WILLIAMSON COUNTY, TEXAS

CHANGE ORDER NUMBER: 8

Project:	<u>Great Oaks Dr. Improvements</u>
Roadway:	<u>Great Oaks Dr @ Brushy Creek</u>
CSJ Number:	<u> </u>

Change Order No.8

3/31/2023				
DESIGN SSW	FED. RD. DIV. NO.	FEDERAL AID PROJECT NO.		HWY NO.
DRAWN SSW	6			
DES CHECK JSR	STATE	DISTRICT	COUNTY	SHEET NO.
DRN CHECK JSR	TEXAS	AUS	WILLIAMSON	405A OF 491
	CONTROL	SECTION	JOB

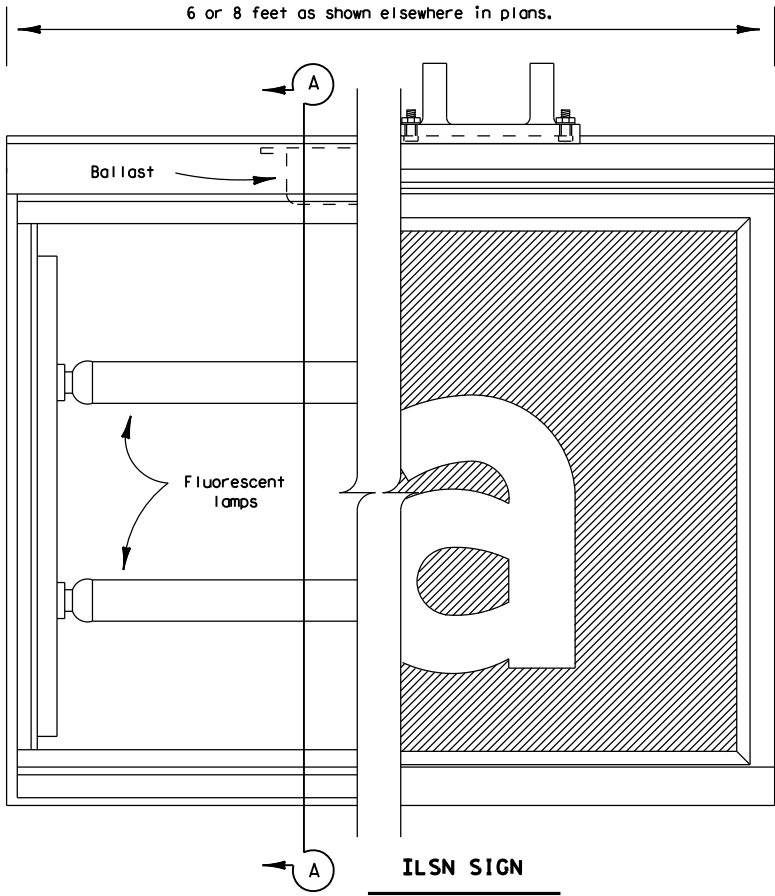
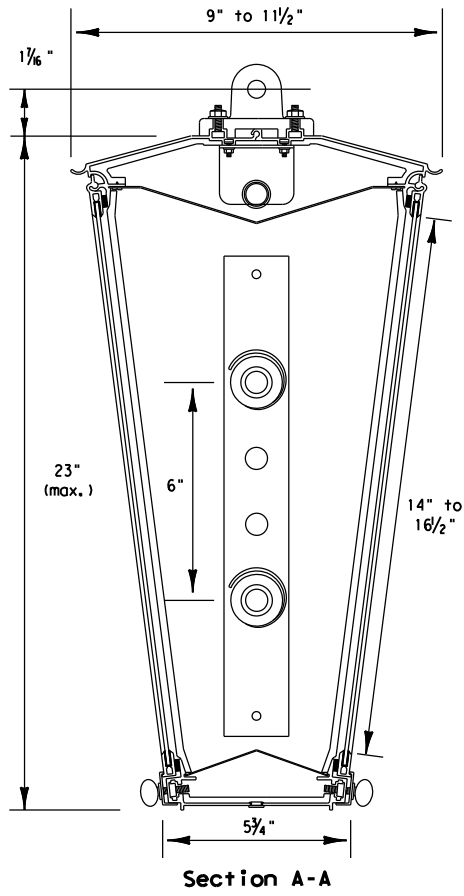
1 REV-1 CONSISTS OF NEW
STRUCTURAL DETAILS FOR
CLEARANCE SIGN 7-1

RFI 34 - ATTACHMENT #1

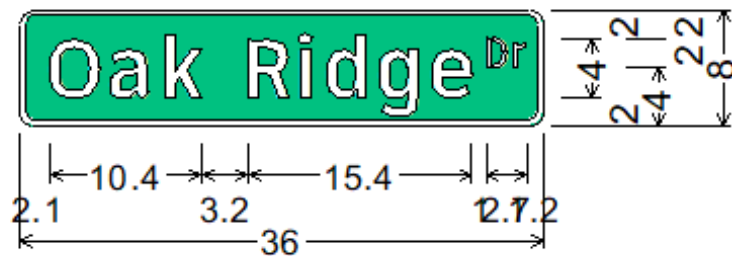
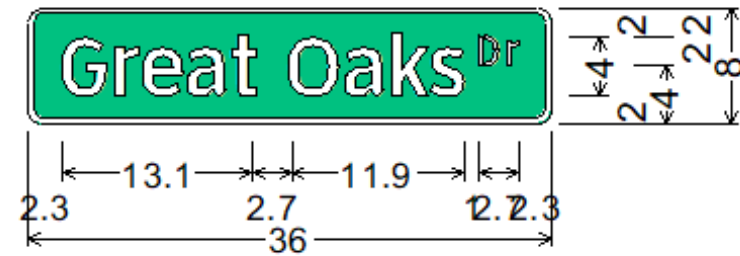
Optional Street Name Signs at Oak Ridge At-Grade Intersection
(signs should have 4" or 6" tall lettering - both options shown below)

Optional Street Name Signs at Brushy Creek Intersection (mounted on traffic signals)

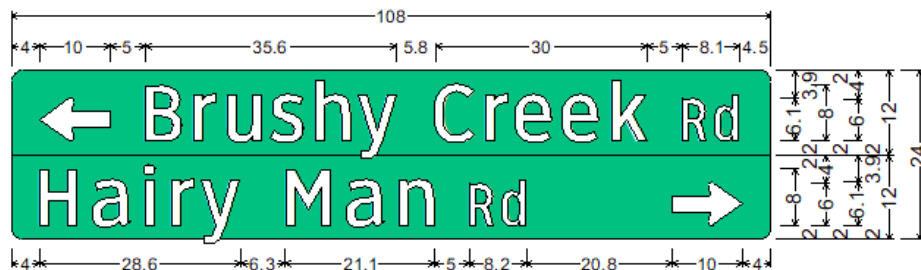
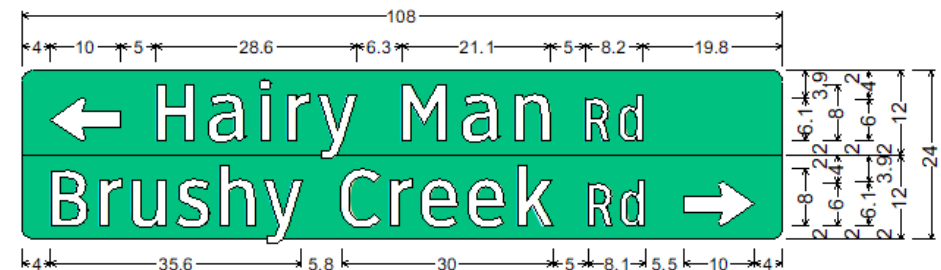
Use double-line street name signs with 8" tall lettering

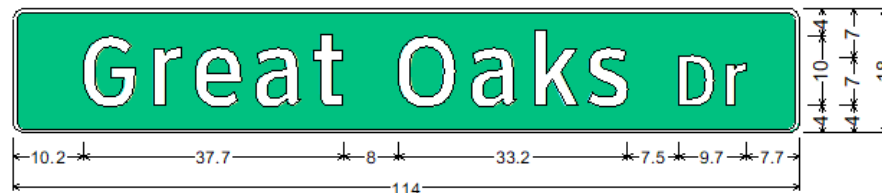
Use single-line street name signs with 10" tall lettering
